**Agenda
Special Meeting
of the Mary Esther Local Planning Agency
November 17, 2025 - 5:00 PM
195 Christobal Road – North, Mary Esther, FL 32569**

SUBJECT: Big Box Retail/ Grocery Market Major Preliminary Development Order

PDO SET - FOR APPROVAL
MARY ESTHER MARKETPLACE & RESIDENCES
BIG BOX RETAIL
City of Mary Esther, FL
PREPARED FOR: Radiant Partners

UNITY OF TITLE BOUNDARIES

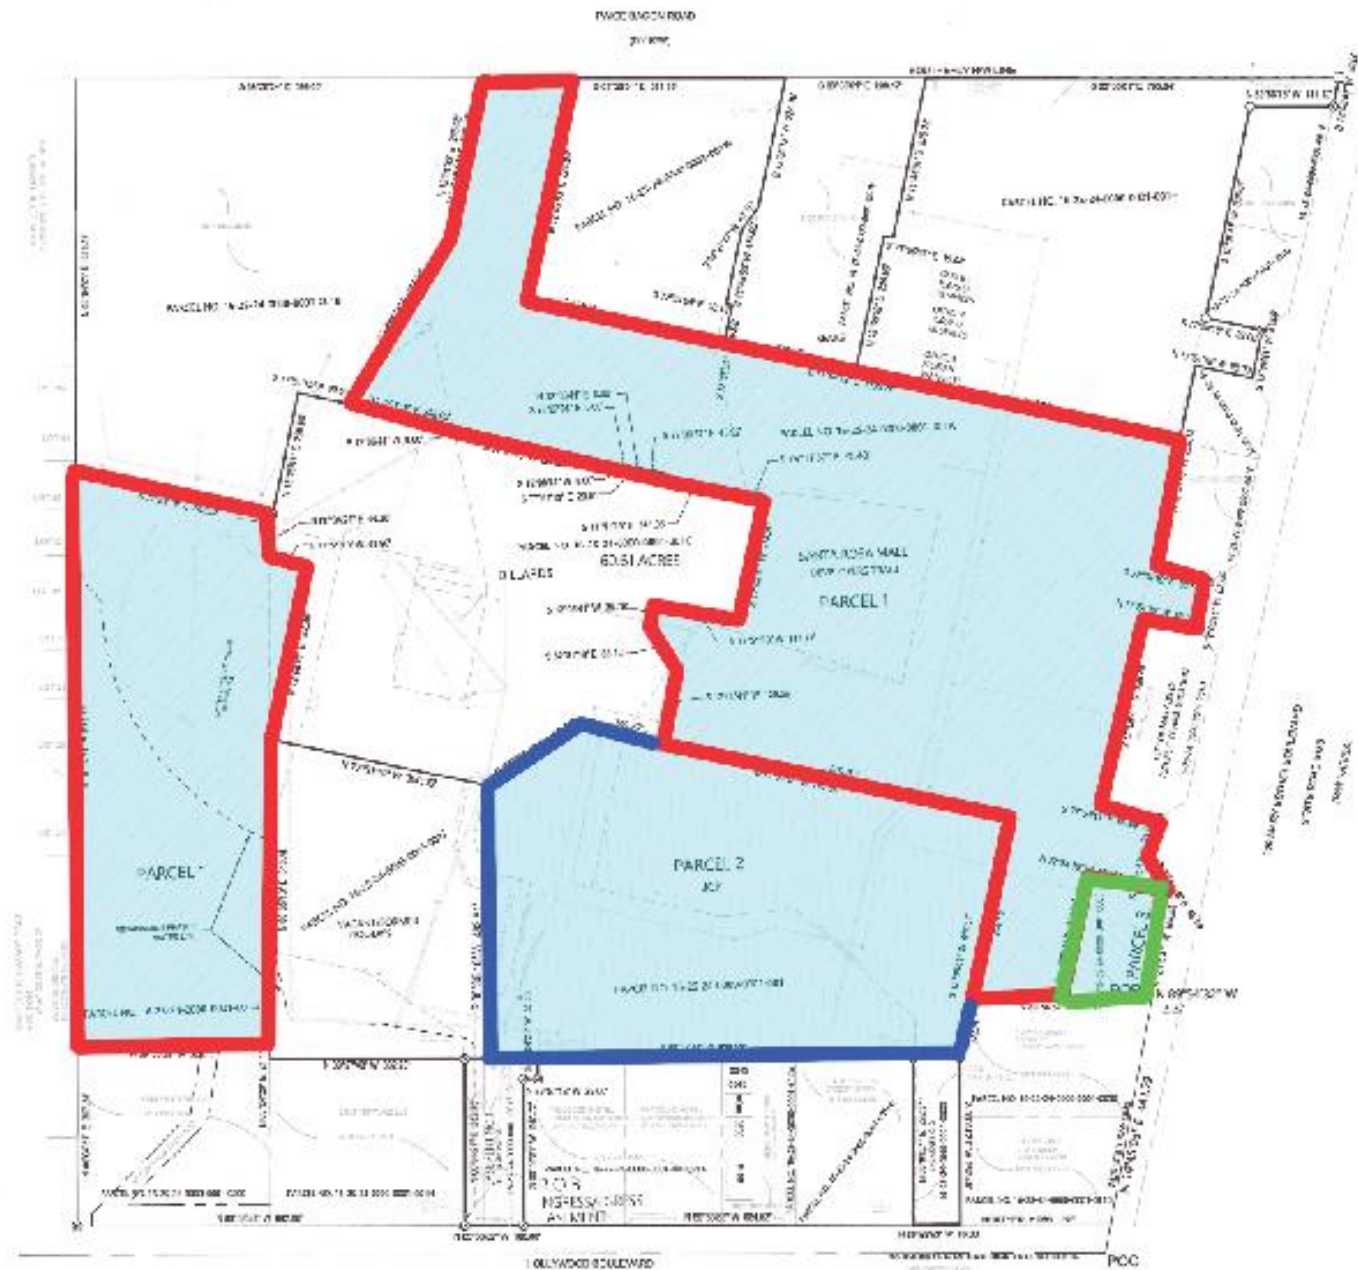
Staff identified a potential zoning conflict related to the proposed rezone of Parcel 1. A portion of Parcel 1 is bordered by Parcels 2 and 3, and the rezoning application proposes that Parcel 1 be rezoned to a Planned Mixed-Use Development District (PMDD).

If this occurs, the property would have split zoning between the existing C-2 (General Commercial) and PMDD, which is not permitted under the Land Development Code. Staff has advised the applicant that dual zoning within a unified parcel cannot be supported and may create future complications in the PDO and FDO process, including conflicts with use permissions, development standards, and enforcement.

Despite these concerns, the owner has elected to proceed with the current PDO application and is aware of the implications. Staff will require the zoning issue to be resolved prior to or concurrent with final platting and future rezoning actions.

1. Submit an exact resolution to fix the Unity of Title/ Zoning issue.
2. Confirm that the Unity of Title will not merge parcels with differing zoning designations; and if needed to revise the Unity of Title, create a plat through the platting process and/or revise legal descriptions as necessary to prevent dual zoning conflicts.

“As discussed, the current project boundary for the PMDD does not include the portion of Parcel 1 being utilized by the current PDO development, except for ingress/egress from Mary Esther

Blvd (such ingress/egress easement to be addressed at the time of platting for the PMDD). Let me know if you need anything further from me on this.”
